Re: Turkey Point Units 3 and 4
Docket Nos. 50-250 and 50-251
Response to Request for Additional Information for the
Review of the Turkey Point Units 3 and 4
License Renewal Application

ATTACHMENT 1
RESPONSE TO REQUEST FOR ADDITIONAL INFORMATION
DATED JANUARY 31, 2001 FOR THE REVIEW OF THE
TURKEY POINT UNITS 3 AND 4,
LICENSE RENEWAL APPLICATION
ENVIRONMENTAL REPORT
SEVERE ACCIDENT MITIGATION ALTERNATIVES

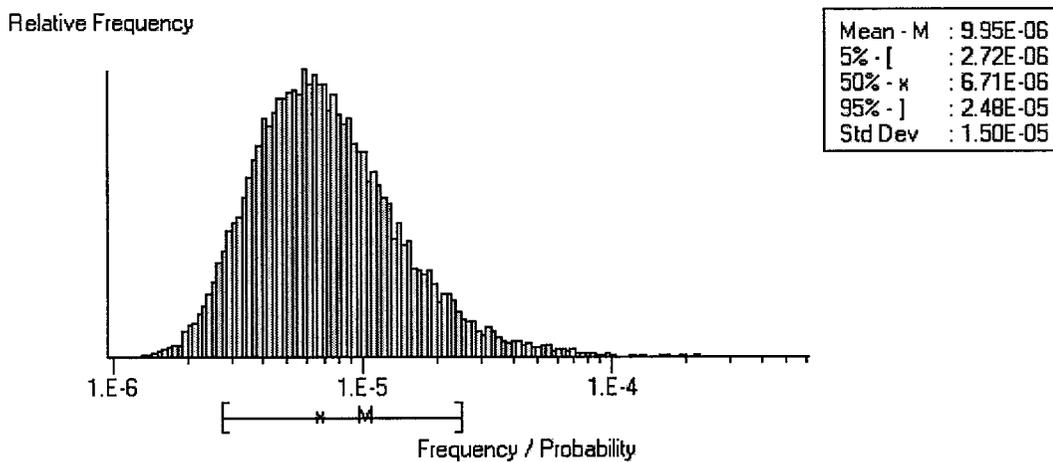
Please provide the uncertainty range associated with the internal events CDF for the base-case PRA. Please show the impact of considering the uncertainties in the estimated CDF on the current SAMA cost-benefit conclusions. If the uncertainties in estimated CDF are not available, please determine the qualitative risk impact by considering the impact of uncertainty ranges as reported in typical level-1 PRA (e.g., NUREG-1150), on the estimated risk results.

In 2000, an update of the Turkey Point PSA was performed. A plot of the uncertainty distribution of the latest internal events CDF is shown below.

The 95th percentile associated with this distribution is 2.48E-05/Yr. The SAMA baseline CDF of 1.62E-05/Yr corresponds to the 88th percentile of the latest CDF distribution. Other factors that offset the higher CDF associated with higher failure rates include modeling uncertainties and cost estimates. For example, additional credit for severe accident guidance could have been taken to reduce the likelihood of containment failure and fission product release. Plant specific implementation of SAMA candidates may be complicated by space limitations, outage cost, regulatory requirements, seismic, fire and other considerations. These factors overestimate the benefit or underestimate the cost. It is concluded that the effect of considering these uncertainties associated with the SAMA cost-benefit estimate would, in effect, offset the uncertainties associated with the CDF estimates, thus making the conclusions robust. No SAMA candidates are considered cost-beneficial even when a higher-confidence CDF is used.
